RE: Former Thrifty Oil Co. Station #049
3400 San Pablo Avenue
Oakland, CA
Requested Documents

RE: Former Thrifty Oil Co. Station #049
3400 San Pablo Avenue
Oakland, CA
Work Plan for Additional Site Assessment and Remedial System Upgrade

RE: **Former Thrifty Oil Co. Station #049**
3400 San Pablo Avenue
Oakland, CA
Addendum to Workplan for Additional Site Assessment and Remedial System Upgrade

SITE PLAN AND RECOVERY SYSTEM LOCATION.
 --- THRIFTY SERVICE STATION NO. 49
 3400 SAN PABLO AVE.
 OAKLAND, CA

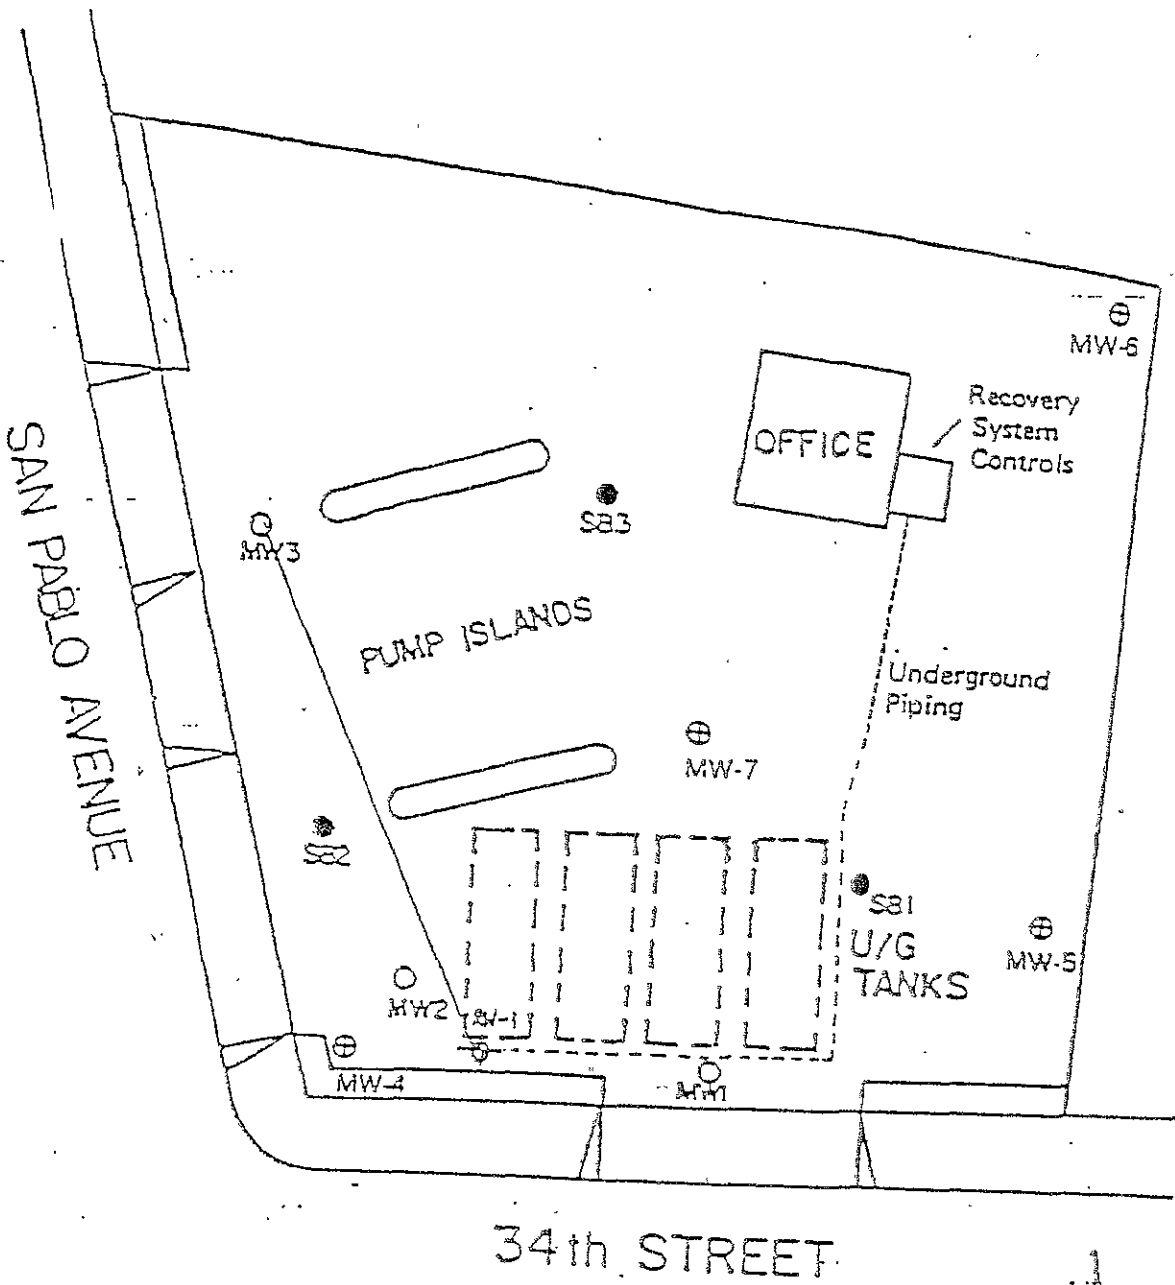
I received and reviewed the December 2002 Work Plan for Additional Site Assessment and Remedial System Upgrade. The proposal to perform a well and conduit survey is acceptable. Also acceptable is the proposal to install new piping and connect well MW-4 to the remediation system. However, I do not believe the one proposed well is adequate to delineate the extent of the contaminant plume. Groundwater beneath the site has flowed from northwest to southwest. I would like to suggest that several soil borings be advanced along San Pablo and 34th Street. Analytical results of soil and grab groundwater samples from these boreholes will help to determine the best location for permanent groundwater monitoring well(s). Let me know if this is doable with Thrifty Oil. If so, you should submit an amended workplan within 21 days of the date of this email. Borings and wells should have shallow screen intervals (to reduce sample dilution) and depth to water has only ranged from 7 to 10 feet bgs.

To delineate the contaminant plume, Thrifty proposes to install one off-site down-gradient groundwater monitoring well (MW-8) in 34th Street, as presented on **Figure 1**. The proposed well is approximately 40 feet down-gradient from monitoring well MW-4. The following activities will be associated with this task:

Figure 2 CONCEPTUAL RECOVERY SYSTEM SCHEMATIC

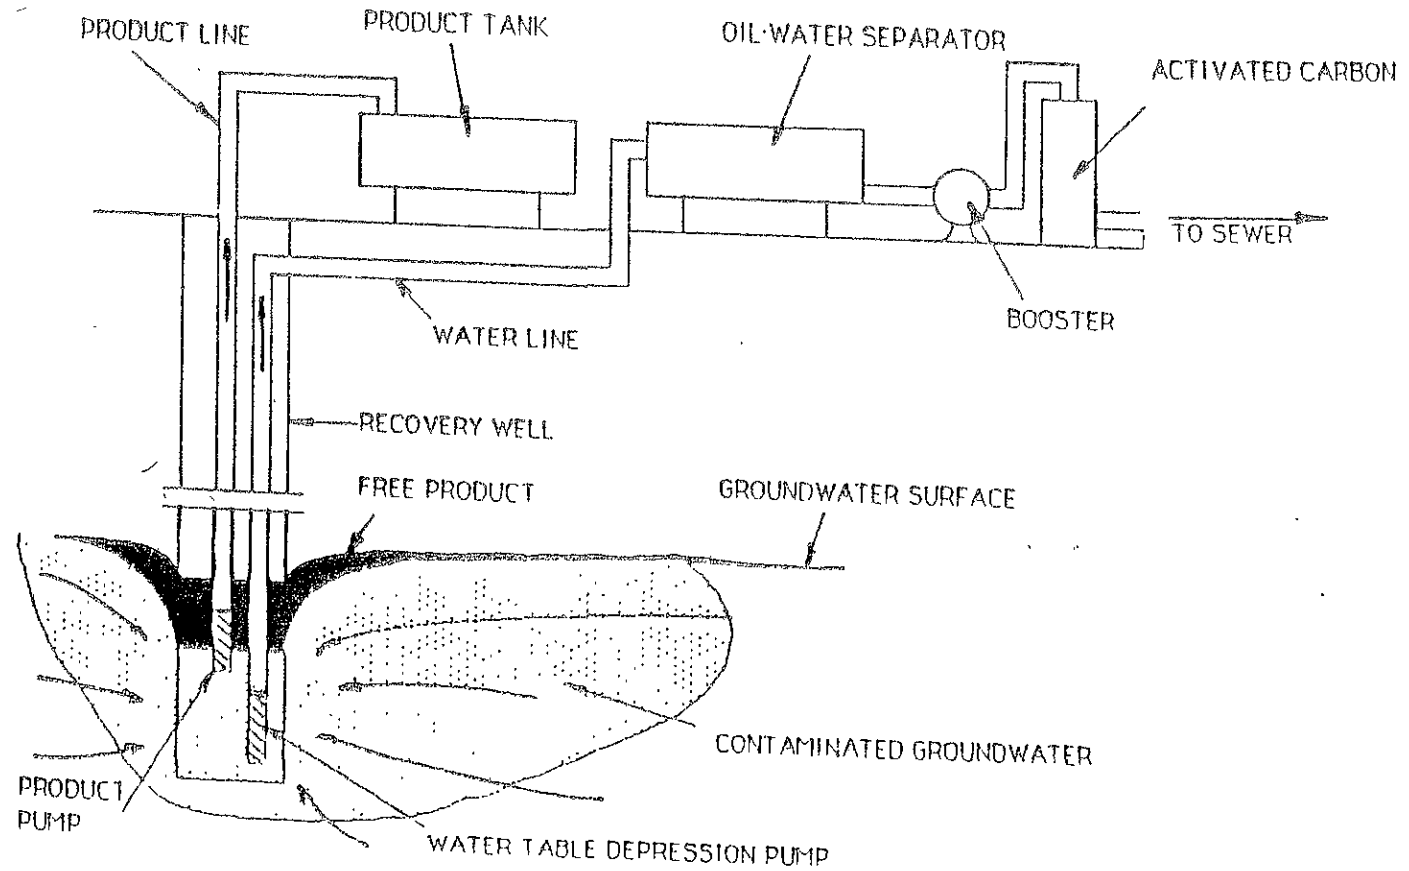
I have completed review of Thrifty Oil Co.'s July 2002 *2nd Quarter 2002, Status Report and Proposal to Upgrade the Existing Remediation System* report prepared for the above referenced site. Thrifty's proposal to overhaul and upgrade the existing remediation system is acceptable.

- The proposed upgraded remediation system will consist of two down hole automatic air-powered pumps (pneumatic) installed within wells MW-4 and RW-1, a 250 to 500-gallon holding tank, and a transfer pump. Water will be pumped from the two recovery wells into the holding tank, and then be pumped by the transfer pump to the first of three 250 pound activated carbons canisters in series. When the water exits the third carbon canister, the treated water will be discharged to the sewer. As with the current groundwater system, samples will be collected at selected ports before the water is discharged to the sewer to ensure water quality standards are met.
